Subject: Intermountain Generating Station Unit 2 Low NO_x Burners

Ref: Response to IPSC Letter Dated July 31, 2006

Intermountain Generating Station Unit 2 Low NO_x Burners
Contract 04-45606; Response to ABT Letter dated May 9, 2006

Front wall looking North (Tips to have air sleeve moved back.) **Tip to be replaced**

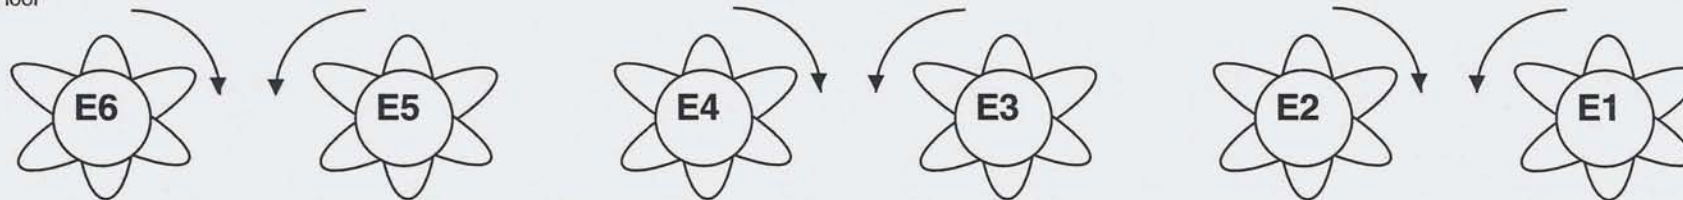
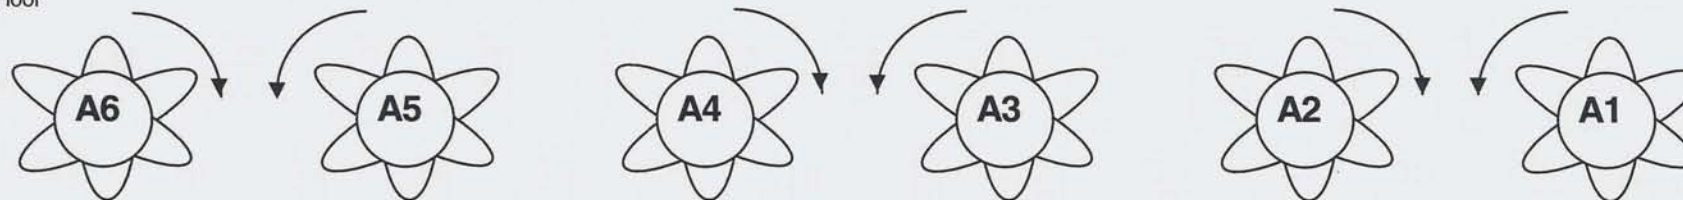
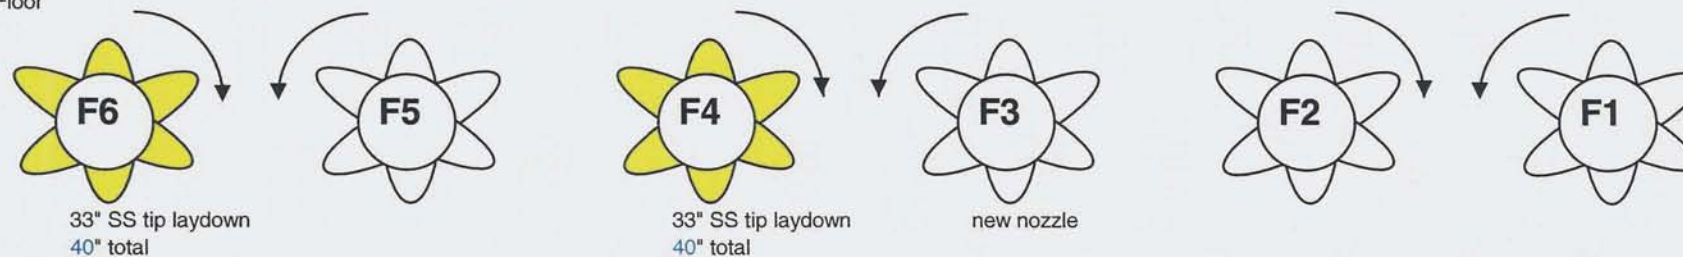
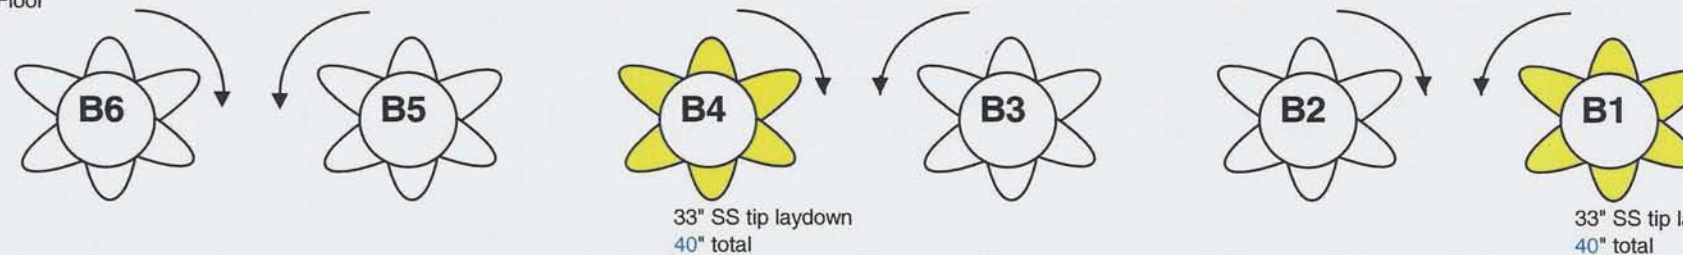
Tips removed and replaced designated in yellow, all others were repaired with segment wear liners on all 6 pedals.
